WATERVUE

643-651 HUNTER STREET NEWCASTLE NSW 2300

DEVELOPMENT APPLICATION SHEET LIST		
DRAWING NO.	TITLE	REVISION
DA000	PLAN - LOCATION & DRAWING SCHEDULE	F
DA002	SITE ANALYSIS	B
DA003	PREDICT LOCATION PLAN	C
DA005	SITE PLAN	B
DA006	SHADOW DIAGRAMS	B
DA007	SHADOW DIAGRAMS	B
DA008	SHADOW DIAGRAMS	A
DA009	SOLAR ACCESS DIAGRAM	B
DA010	VENTILATION DIAGRAMS	B
DA011	PLANNING - GFA	C
DA012	UNIT AREA FOR CARPARKING GEN.	B
DA101	GROUND FLOOR	E
DA102	PARKING LEVEL 1	D
DA103	PARKING LEVEL 2	C
DA104	PARKING LEVEL 3	C
DA105	PLAN - PODIUM	E
DA106	PLAN - TYPICAL LOWER	D
DA107	PLAN - TYPICAL UPPER	C
DA111	PLAN - PENTHOUSES	B
DA112	ROOF	B
DA200	STREETSCAPE ELEVATIONS	B
DA201	ELEVATIONS - NORTH AND EAST	F
DA202	ELEVATIONS - SOUTH AND WEST	C
DA301	SECTIONS	C
DA321	RAMP SECTION CARPARK	C
DA401	PERSPECTIVE	B
DA402	PERSPECTIVE	B
DA403	PERSPECTIVE	B
DA409	MATERIALS + FINISHES	B
DA801	PODIUM LEVEL PRIVACY SCREENS	A
DA802	SIGNAGE DESIGN INTENT	A

DRAWING No. **DA103**
DRAWING TITLE **PARKING LEVEL 2**
SCALE **1:100 @ A1**
DATE **2022**

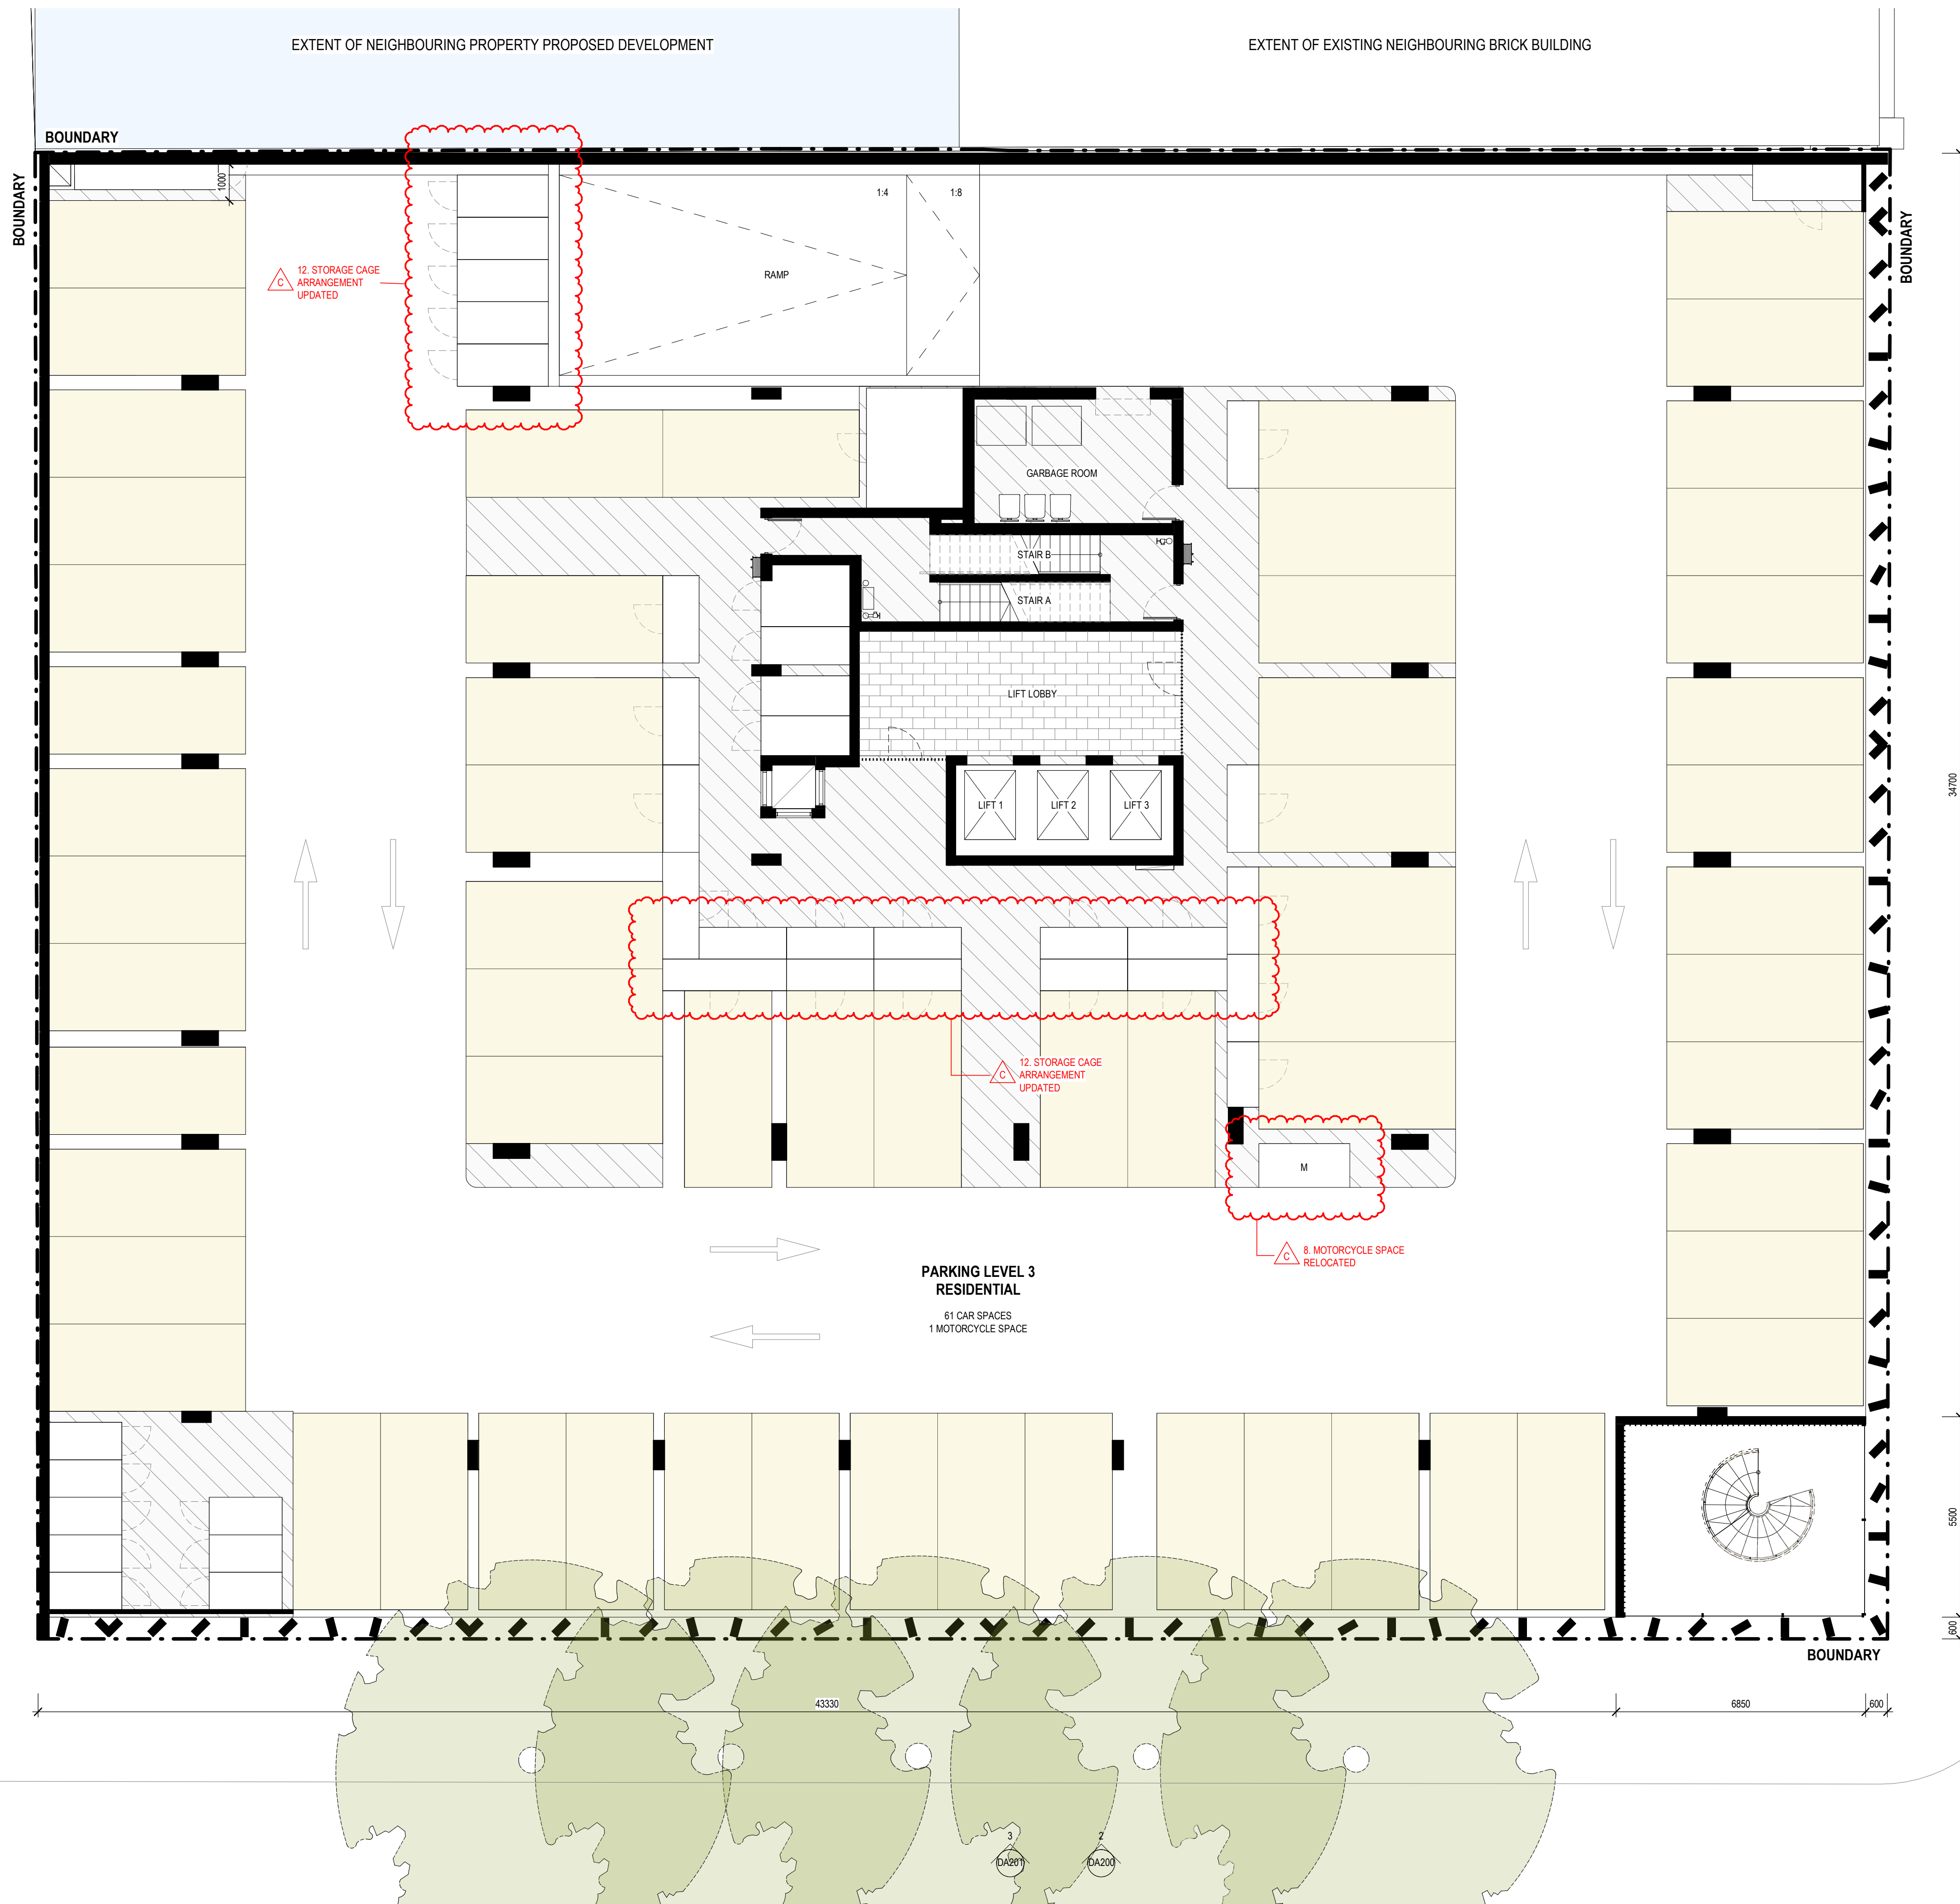
- GROUND FLOOR CARPARKING LEVEL LOWERED BY 300MM
- DRIVEWAY GRADES UPDATED TO SUIT UPDATED PARKING LEVEL
- DOOR TO FIRE EGRESS CORRIDOR RELOCATED
- STEP ADDED TO FIRE EGRESS PATH TO SUIT UPDATED PARKING LEVEL
- STEPS AND PLATFORM ADDED TO MSB ROOM TO SUIT UPDATED PARKING LEVEL
- MAIL ROOM ADDED TO RESIDENTIAL LOBBY
- MAILBOXES RELOCATED INTO THE RESIDENTIAL LOBBY
- MOTORCYCLE SPACE DISTRIBUTION ACROSS L1, L2 AND L3 UPDATED (TOTAL REMAINS THE SAME)
- SECURE ENTRY ADDED AT BASE OF RESIDENTIAL CARPARK RAMP
- GF TO L1 RAMP LENGTH UPDATED TO SUIT UPDATED GROUND FLOOR PARKING LEVEL
- GARAGE ADDED TO L1 AND L2
- STORAGE CAGE ARRANGEMENT UPDATED
- LANDSCAPE COURTYARD ACCESS DOOR ADDED TO PODIUM LEVEL
- POOL PERGOLA SHOWN IN ELEVATION

DRAWING No. **DA105**
DRAWING TITLE **PLAN - PODIUM**
SCALE **1:100 @ A1**
DATE **2023**

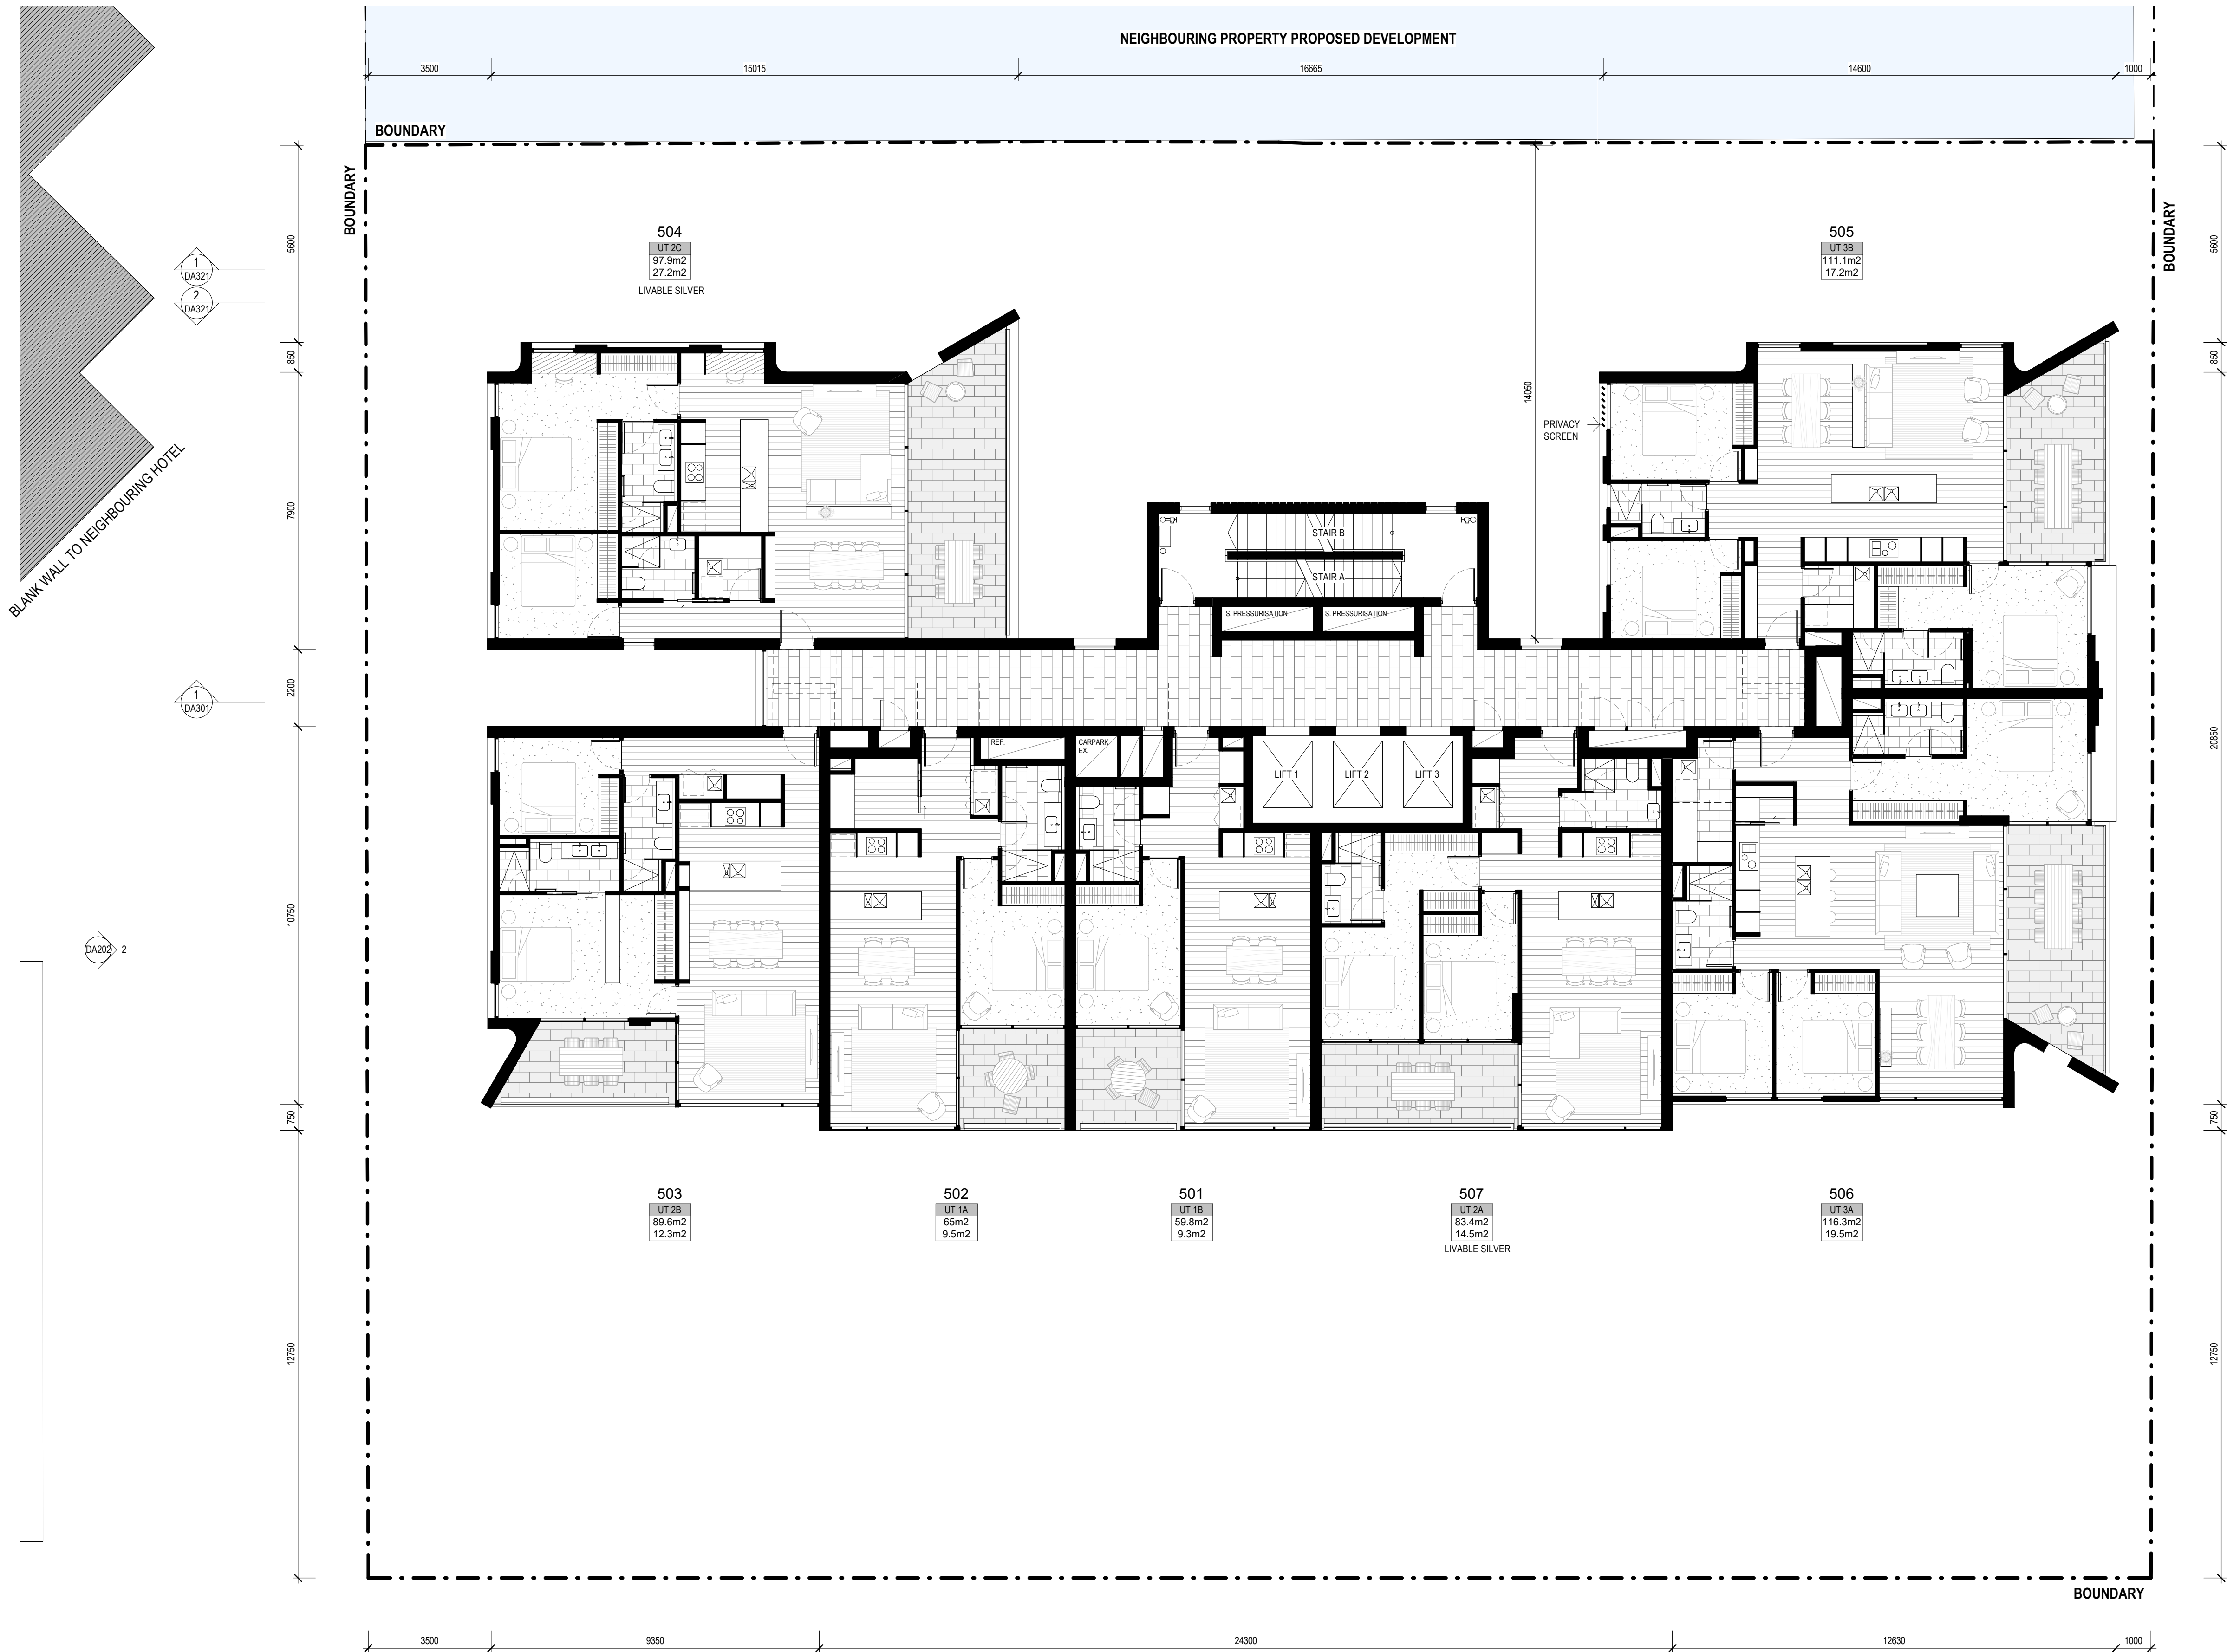
DA RfIs - 27.03.2023
24m BUILDING SEPARATION LINE ABOVE 45m INDICATED
PRIVACY SCREEN LOCATION CLARIFIED
